ON-SITE SEWAGE DISPOSAL SYSTEM HOWARD COUNTY HEALTH DEPARTMENT BUREAU OF ENVIRONMENTAL HEALTH

ADDRESS: 14221 Day Farm Road PROPERTY OWNER: Paul Borthwick

SEWAGE DISPOSAL SYSTEM

SITE INSPECTION SHEET

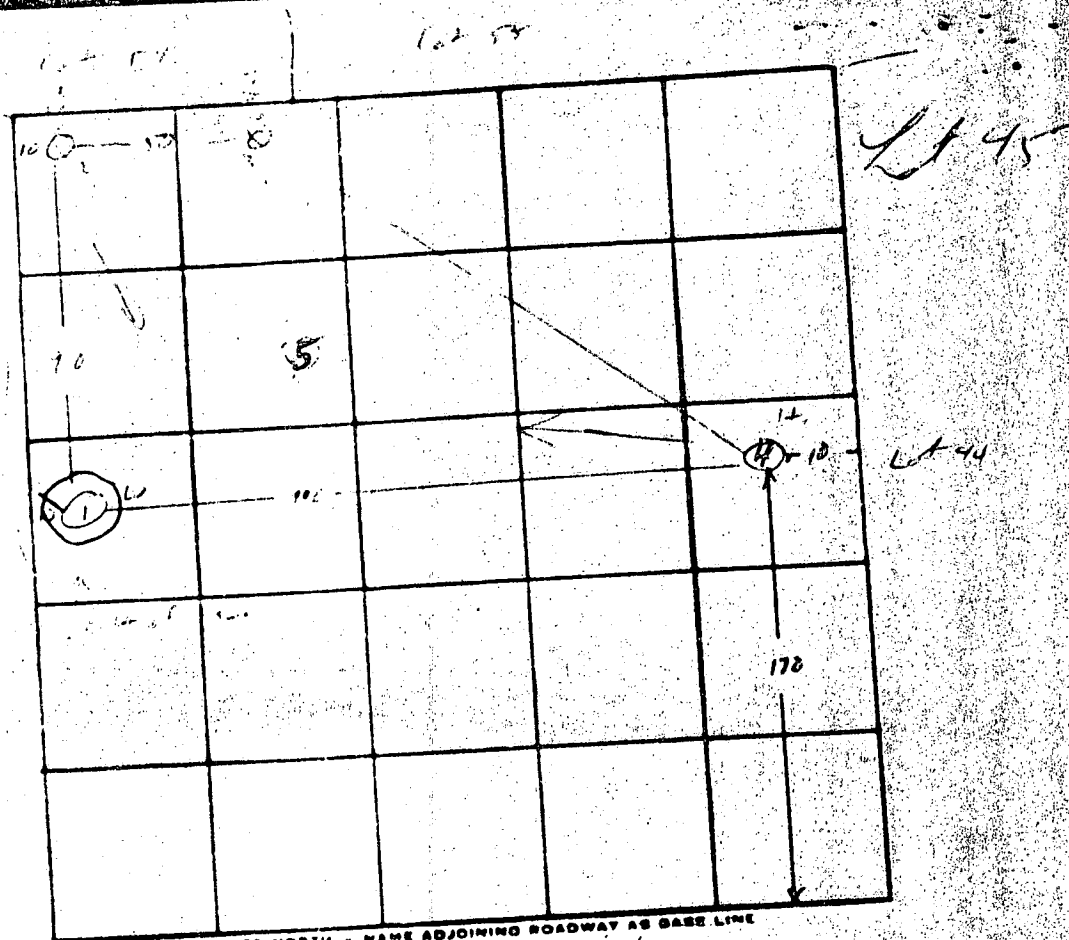
Trenches should be connected at end (FF + DM)
 Brittingham informed. (GLK)

DISTRIBUTION BOX, LEVEL 2x2x1 need baffle - OK

REMARKS 4 Apr. 79 - Specifications previously revised in field by JF/DM. Trench blown-out to 3-4' width in parts - last 30' of each trench slightly downhill. Beginning portion of trench should have invert at 2-3' below O.G., and by keeping distrib. pipe level, approx. 1' below O.G. AT TRENCH END. LEAVING 4-5' stone under pipe. Instructed Brittingham not to allow pipe to rise above O.G. (last 20'-30' of trench may not be piped), to position TEE-connection to feed upper trench (1) first, to call when gravel, cleanouts, sewers installed (GLK)

LOCATION DIAGRAM

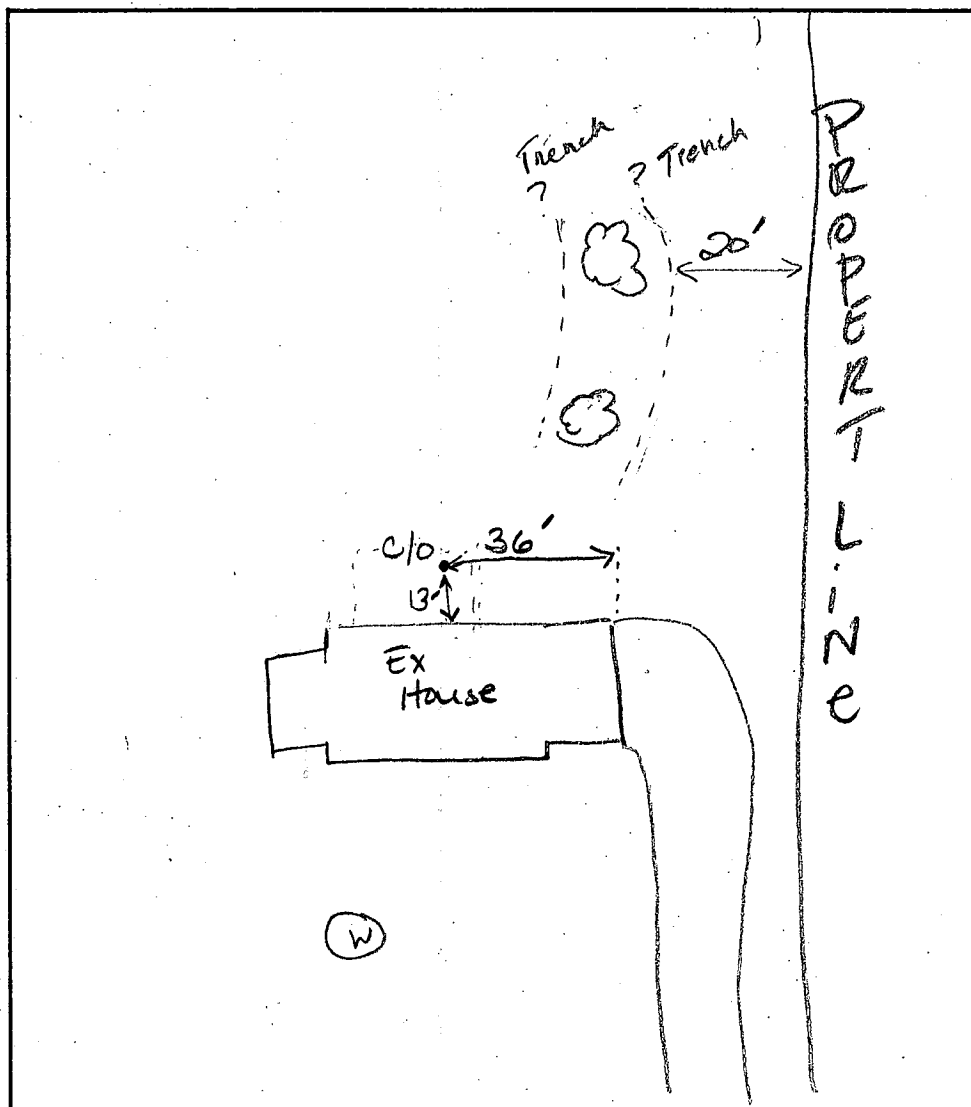
4/29/02
COMMENTS: Septic TANK Cleanout is directly under
the deck (K6) CALLED 3:25 - left message (K6)

528-02
OAK release B.P.
For replacement tank
